Access Compliance Report Public Rights-of-Way (Curb Ramps)

Main Street: FOSTER_RD Cross Street: CHANNING_WAY Location: NE

ADA ID: RPAT211206114949 Ramp Type: Type 1 - Perpendicular Diagonal Initial Pass/Fail: Pass Overall Compliance: No Severity Score: 0

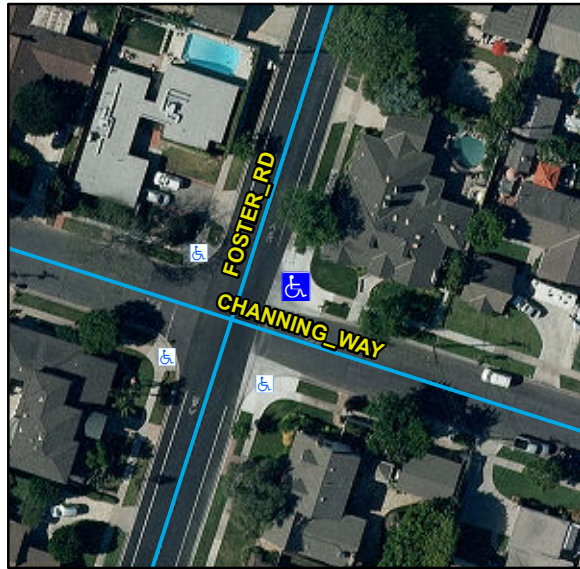
Remove & Replace Landing.
